SUNDRY NOTICES AND REPORTS ON WELLS
Do not use this form for proposals to drill or to re-enter an abandoned well. Use form 3160-3 (APD) for such proposals.

Final P&A Procedure Basin Fruitland Coal Formation

Well:	Stacey #2	Field: Basin Fruitland Coal
SL Location:	2045' FNL & 790' FEL (SENE) Sec 6, T26N, R12W, NMPM San Juan County, New Mexico	Elevation: 5894' RKB 5889' GL
		Lease: NOG96061302
		API#: 30-045-29473

Re: Permanent Abandonment
Well: Stacey #2

**COLEMAN OIL GAS, INC.
Stacey #2 PROPOSED P&A**

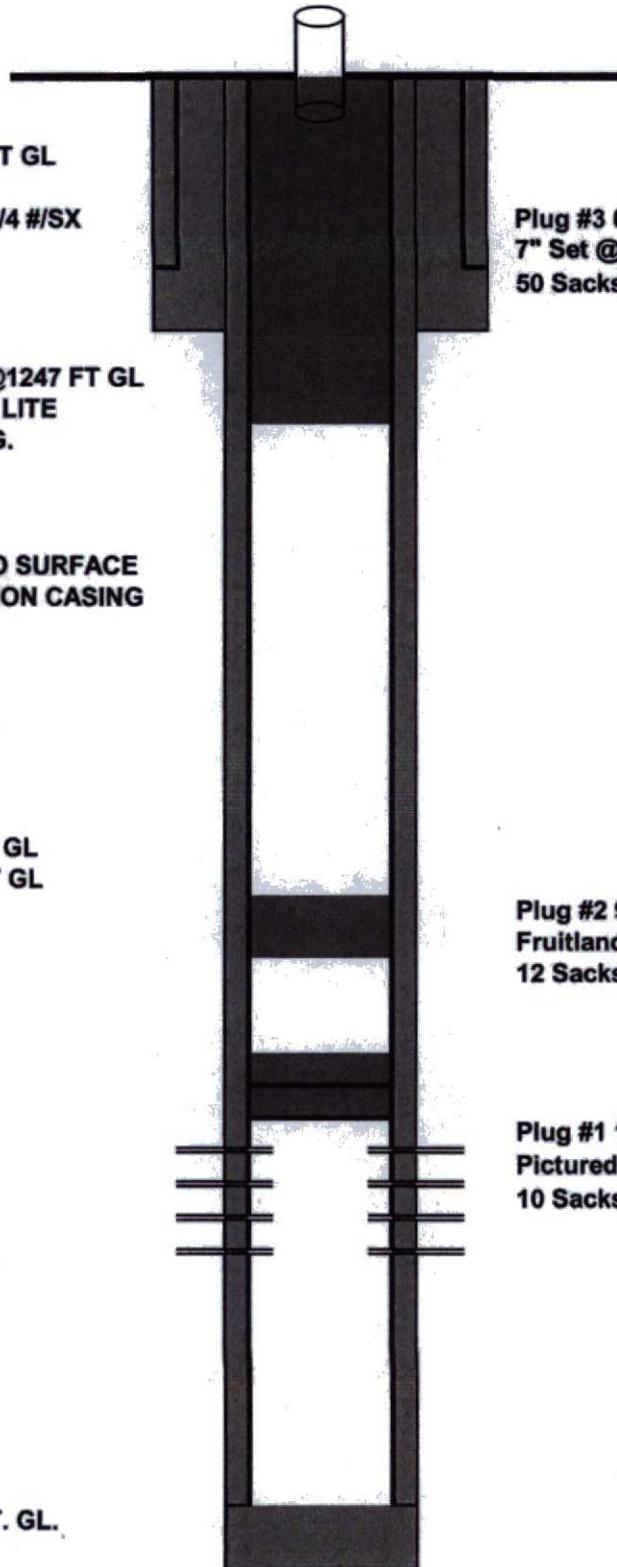
- a) Set plug #2 (878-778) ft. to cover the Fruitland top. BLM picks top of Fruitland at 828 ft.
